**CLEAN AIR ACT (CAA) § 112(r)(1) AND EMERGENCY PLANNING,
COMMUNITY RIGHT-TO-KNOW ACT (EPCRA) § 312
INSPECTION REPORT**

**Pitman Farms Salina Processing Plant
Salina, Utah**

Photo 1. HPR-1 and HPR-2 corrosion

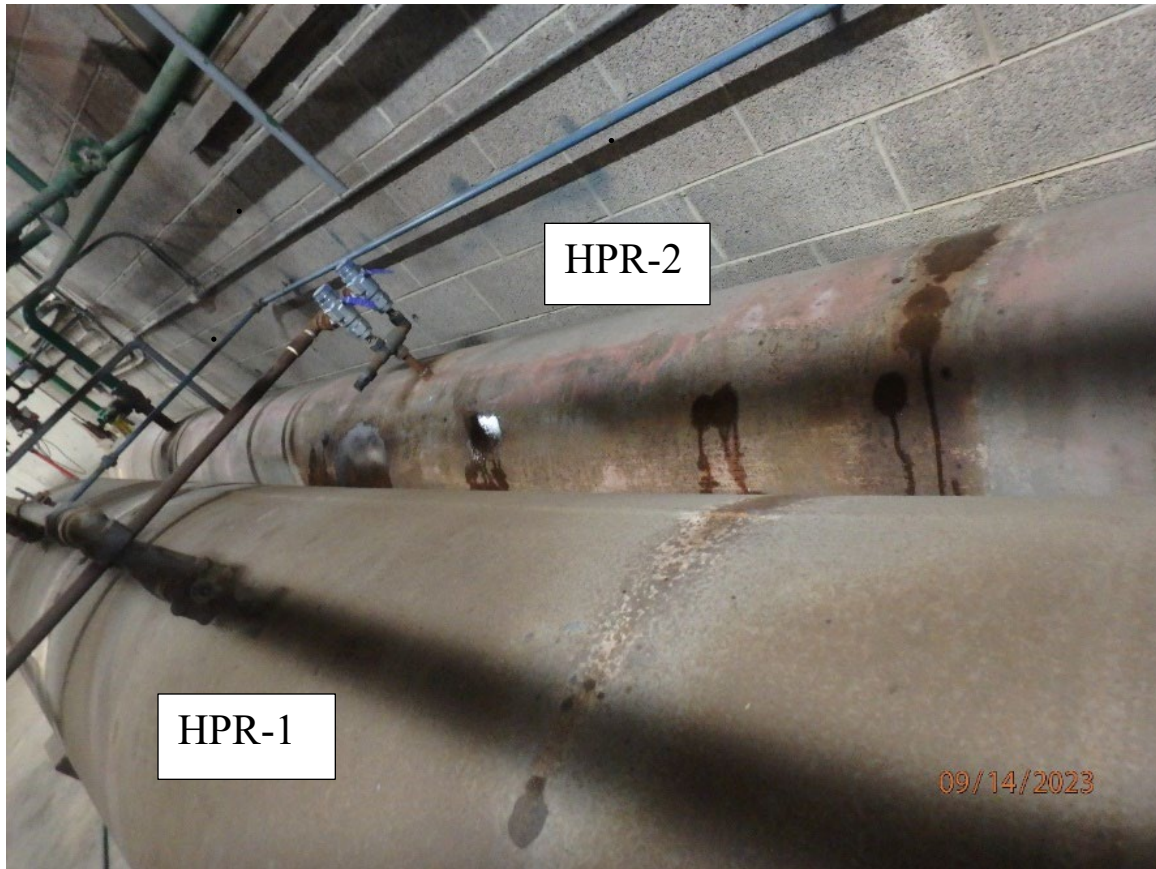
- 16. Copies of the annual inspections for the High-Pressure Receivers (HPR-1 and HPR-2) were requested for 2021, 2022, and 2023. The 3 annual checklists for HPR-2 indicates the nameplate is not legible and complete. The 2021-2023 annual checklists for both high-pressure receivers indicate “slight visible corrosion” even though the receivers have not had any protective coating (i.e. paint) applied since the 2017 inspection and corrosion was observed.**
